Access Compliance Report

Public Rights-of-Way (Curb Ramps)

Intersection ID: 21114	Main Street: BENT_BRANCH_RD	Cross Street: CARMEL_RD	Location: SE
ADA ID: 8E5E7207F785	Ramp Type: Directional1	Initial Pass/Fail: Fail	Overall Compliance: No
		Severity Score: 22.5

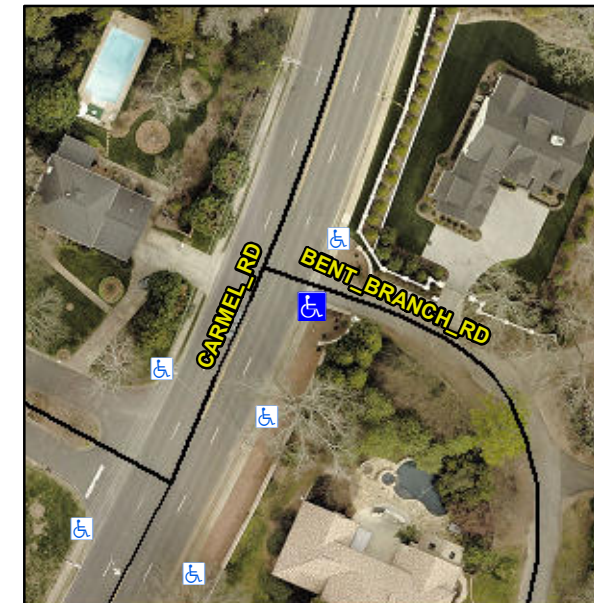
R304.5.1, R304.2.2

Compliance	Description	Data	Compliance	Description	Data
N/A	Ramp Length (in)	80.0	N/A	Grade Break?	N/A
No	Ramp Width (in)	47.0	N/A	Grade Break Slope (%)	0.0
No	Ramp Slope (%)	9.2	N/A	Grade Break XSlope (%)	0.0
Yes	Ramp XSlope (%)	2.8			
N/A	Flare Type LT	N/A	N/A	Flare Type RT	N/A
N/A	Flare Slope LT (%)	N/A	N/A	Flare Slope RT (%)	0.0
N/A	Flare Traversable LT?	N/A	N/A	Flare Traversable RT?	N/A
N/A	Landing Length (in)	0.0	N/A	DWS Provided?	N/A
N/A	Landing Width (in)	0.0	N/A	DWS Contrast?	N/A
N/A	Landing Slope (%)	0.0	N/A	DWS Length (in)	N/A
N/A	Landing X Slope (%)	0.0	N/A	DWS Full Width?	N/A
N/A	Landing Curb? (Y/N)	N/A	N/A	DWS Offset LT (in)	N/A
N/A	Shared Landing?	N/A	N/A	DWS Offset RT (in)	N/A
N/A	Gutter Ponding?	0.0	N/A	Gutter Slope (%)	N/A
N/A	Gutter Lip Ht (in)	0.0	N/A	Gutter X Slope (%)	N/A
N/A	Painted X Walk1?	No		Road Slope (%)	0.0
	X Walk 1 Direction	To NE		Road X Slope (%)	6.9
	X Walk 1 Width (in)	N/A		Clear Space?	N/A

Remove & Replace Entire Ramp.
